Project	IEEE 802.16 Broadband Wireless Access Working Group < http://ieee802.org/16 >	
Title	Message authentication in Distributed Security Architecture	
Date Submitted	2007-07-05	
Source(s)	Masato Okuda Fujitsu Laboratories LTD. Kamikodanaka 4-1-1, Nakahara-ku Kawasaki, Japan. 211-8588	Voice: +81-44-754-2811 E-mail: okuda@jp.fujitsu.com
Re:	IEEE802.16j-07/19, "Call for Technical Comments Regarding IEEE Project 802.16j"	
Abstract	This contribution clarifies message authentication in distributed security architecture	
Purpose	To propose text to describe message authentication in distributed security architecture	
Notice	<i>This document does not represent the agreed views of the IEEE 802.16 Working Group or any of its subgroups. It represents only the views of the participants listed in the "Source(s)" field above. It is offered as a basis for discussion. It is not binding on the contributor(s), who reserve(s) the right to add, amend or withdraw material contained herein.</i>

Message Authentication in Distributed Security Architecture

The Figure-1 shows an explanatory example of a message exchange sequence in distributed security model.

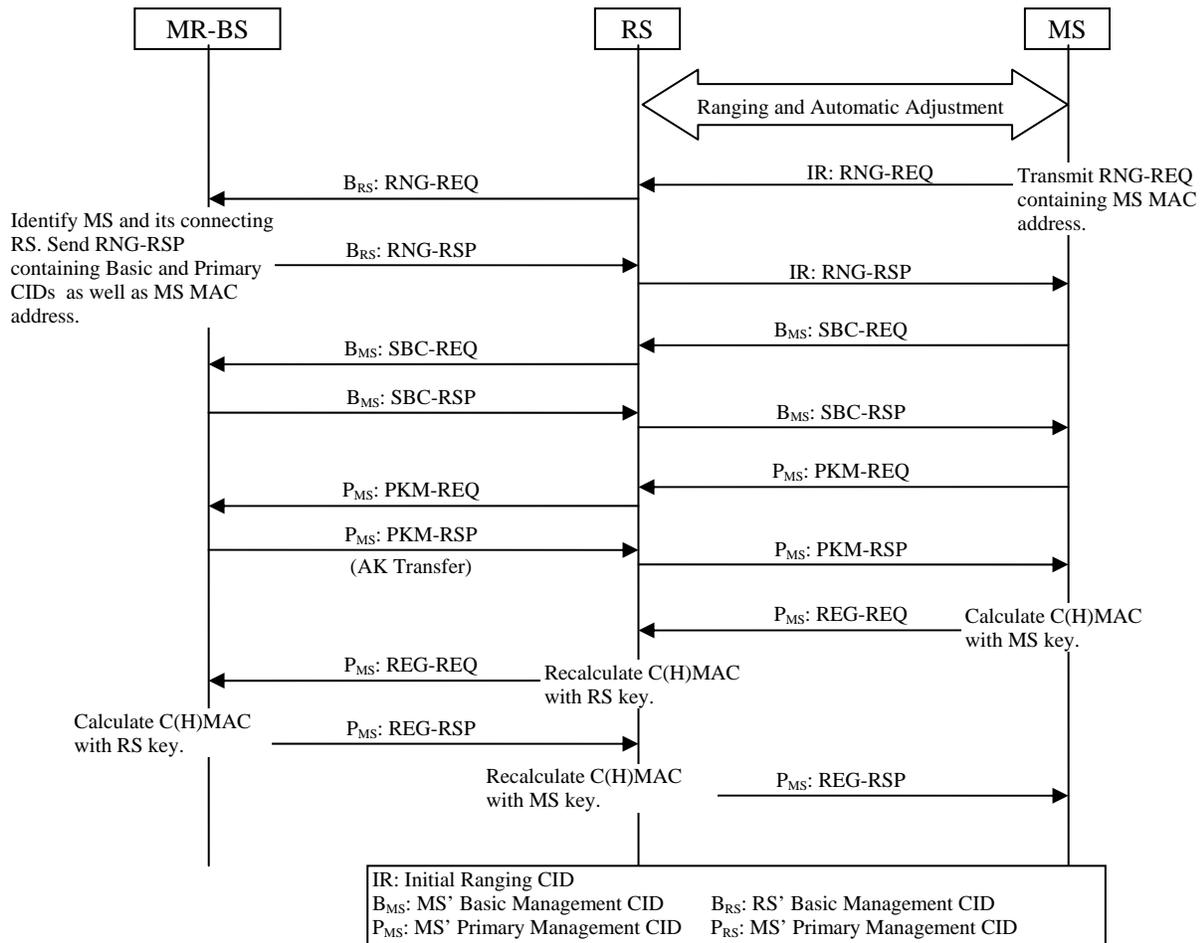
In the figure-1, MAC management messages are exchanged with MS basic or primary CID after RNG-RSP in the same way as centralized security model. However, scope of message authentication (CMAC/HMAC), which is attached to MAC management messages, is different between centralized and distributed security model because MS security context is shared between MS and the access RS in distributed security while it is shared between MS and the MR-BS in centralized one. After completing MS authentication and establishing security association between MS and the access RS (see detail in 7.1), MAC management messages on the access link

shall contain CMAC/HAMC calculated by a key shared between MS and its access RS, while MAC management messages on relay link shall contain CMAC/HAMC calculated by a key shared between RS and the MR-BS. The access RS shall recalculate CMAC/HAMC accordingly when it relays MAC management messages.

Insert the new subclause at the end of the 6.3.9.16.2.2 (Non-transparent RS with Distributed Scheduling):
[6.3.9.16.2.2.1 Message authentication in distributed security model](#)

In the distributed security model where MS security context is shared between the MS itself and its access RS, messages authentication is different from the centralized security model where MS security context is shared between the MS itself and the MR-BS.

Once management CIDs are assigned by the MR-BS during ranging process, MAC management messages are exchanged with MS's MAC management CIDs between MS and MR-BS via RSs as described in the previous subclause. However, scope of message authentication (CMAC/HMAC), which is attached to MAC management messages, is different between centralized and distributed security model because MS security context is shared between MS and the access RS in distributed security while it is shared between MS and the MR-BS in centralized one. After completing MS authentication and establishing security association between MS and the access RS (see detail in 7.1), MAC management messages on the access link shall contain CMAC/HAMC calculated by a key shared between MS and its access RS, while MAC management messages on relay link shall contain CMAC/HAMC calculated by a key shared between RS and the MR-BS. The access RS shall recalculate CMAC/HAMC accordingly when it relays MAC management messages.
